STATE OF FLORIDA
DEPARTMENT OF ENVIRONMENTAL PROTECTION

Staff Analysis Report

**Levy Nuclear Power Plant Units 1 and 2
Site Certification**

Transmission Line Portion

Figure 6 - LCFS

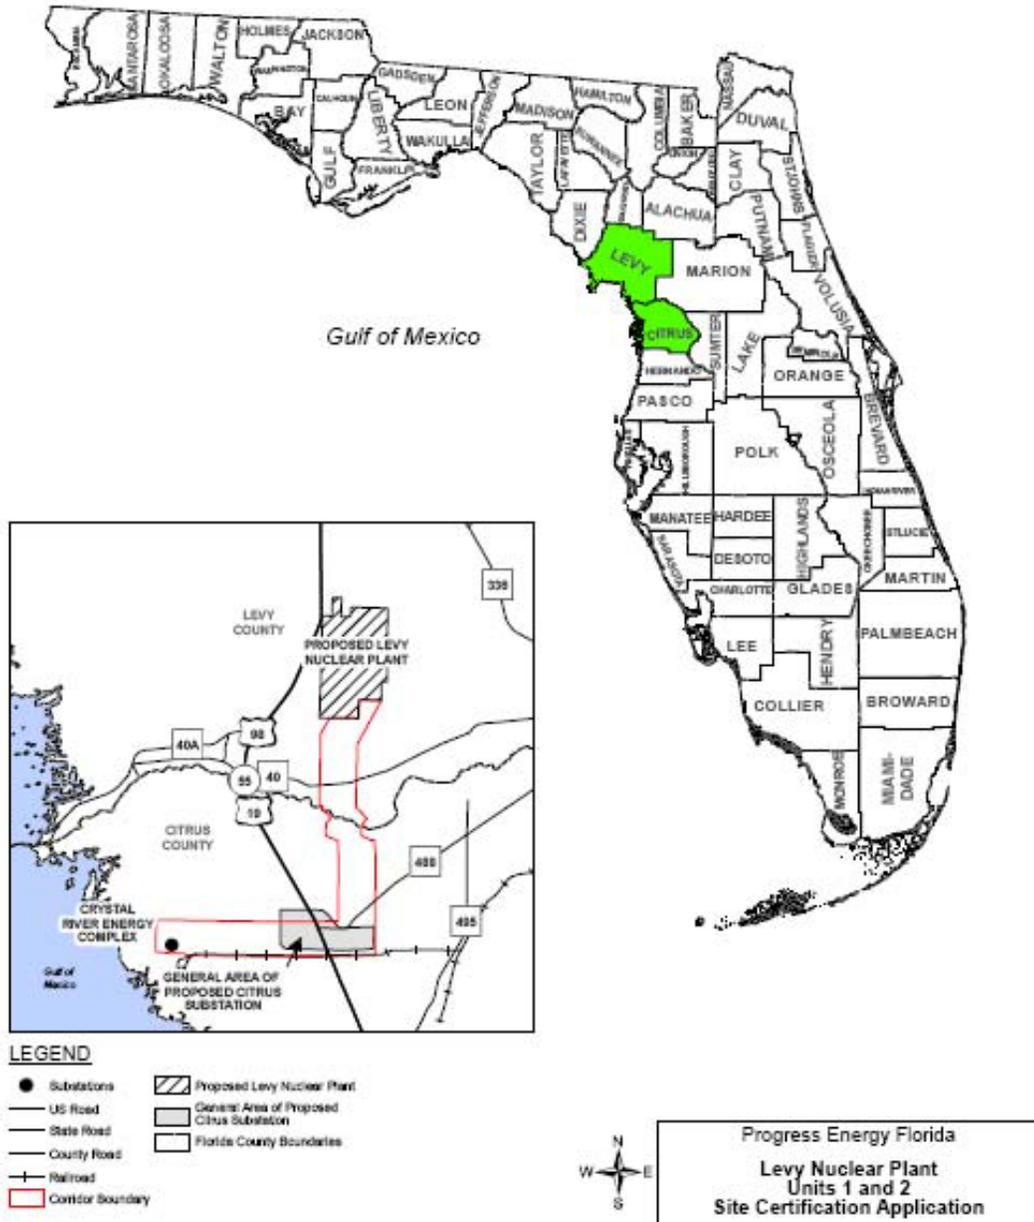
The East Central Florida Regional Planning Council (ECFRPC) reviewed the information concerning the Sumter Line corridor into Lake County and Leesburg. This is a 500 kV transmission line corridor connecting the Levy Nuclear Power Plant and the proposed Central Florida South Substation in Sumter or Lake County.

The Council staff's concerns regard the Development of Regional Impact (DRI) Secret Promise along the southern boundary of the corridor in Lake County. According to Map H of Secret Promise DRI, "Retail and Service" is planned along the southern boundary of CR 470. Progress Energy should work closely with the Secret Promise DRI to ensure the aesthetics of the transmission line and the ROW are consistent with the development occurring south of CR 470.

With consideration of the above conditions, the Council recommends approval of certification (see Appendix II-H). East Central Regional Planning Council conditions are included in Appendix I.

Figure 12 - PHP

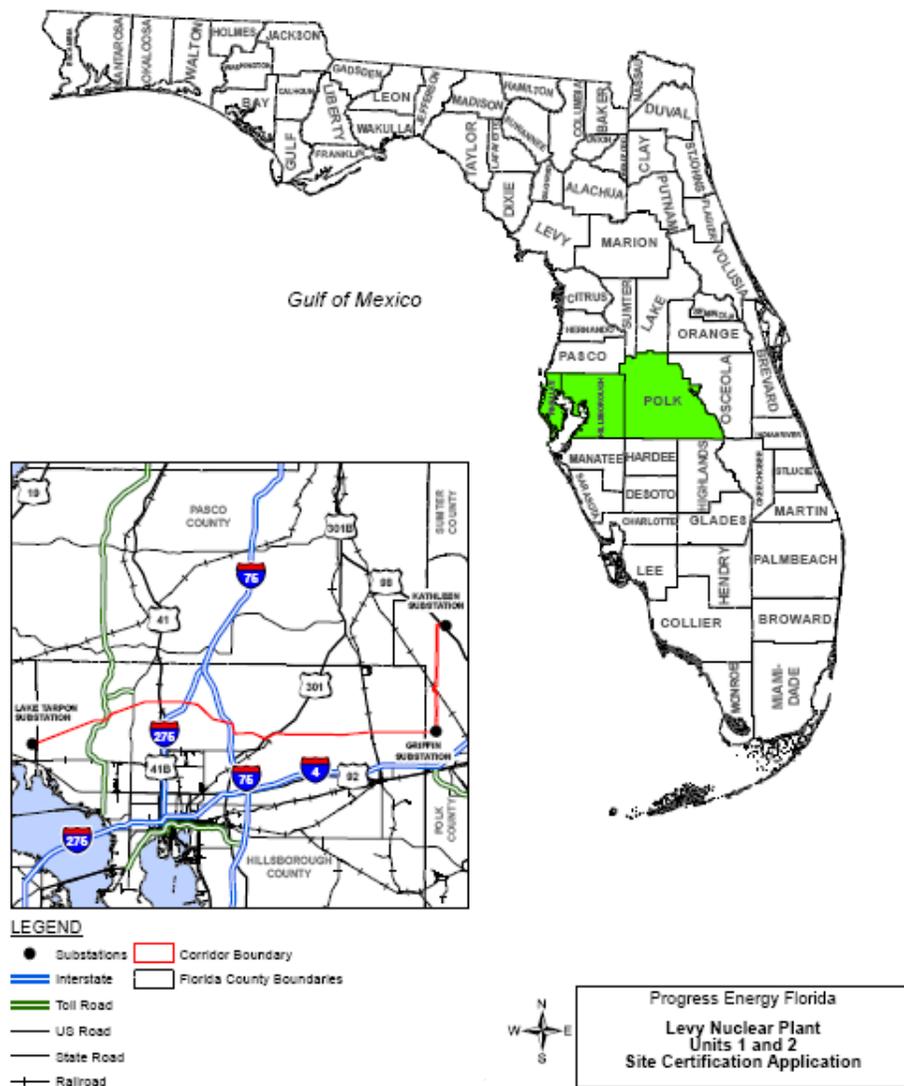
Pinellas County indicated that impacts to Pinellas County are expected to be associated with the alignment from the Kathleen Substation in Polk County that terminates at the Lake Tarpon Substation in Pinellas County, located at the southeastern border of the Brooker Creek Preserve. Pinellas County's primary concerns are the need for coordination prior and during site development, adherence to Pinellas County Comprehensive Plan and land development regulation requirements, and compatibility with the Brooker Creek Preserve Management Plan.

- The Pinellas County Comprehensive Plan represents Pinellas County's growth management plan. The goals, objectives and policies of the adopted Plan have regulatory standing pursuant to **Chapter 163, F.S.** *Attachment Two* to this letter depicts those goals, objectives and policies of the adopted Comprehensive Plan that need to be included as Conditions of Certification.
- Additionally, coordination with Pinellas County staff, including *Environmental Management* staff and *Building and Development Review* staff, is required prior to any final decisions on a specific corridor alignment and development of a specific plan for site development and maintenance.

- Maintenance activities are not to impact/compromise the adjacent Preserve, and should – if possible – complement the management strategies within the Preserve associated with the adopted *Brooker Creek Preserve Management Plan*.

TBRPC recommended that the application for certification of the 230 kV transmission line through Hillsborough and Pinellas counties, including the cities of Plant City, Tampa and Oldsmar, be approved, subject to the recommended conditions set forth in Appendix I. See Appendix II-J for TBRPC agency report.
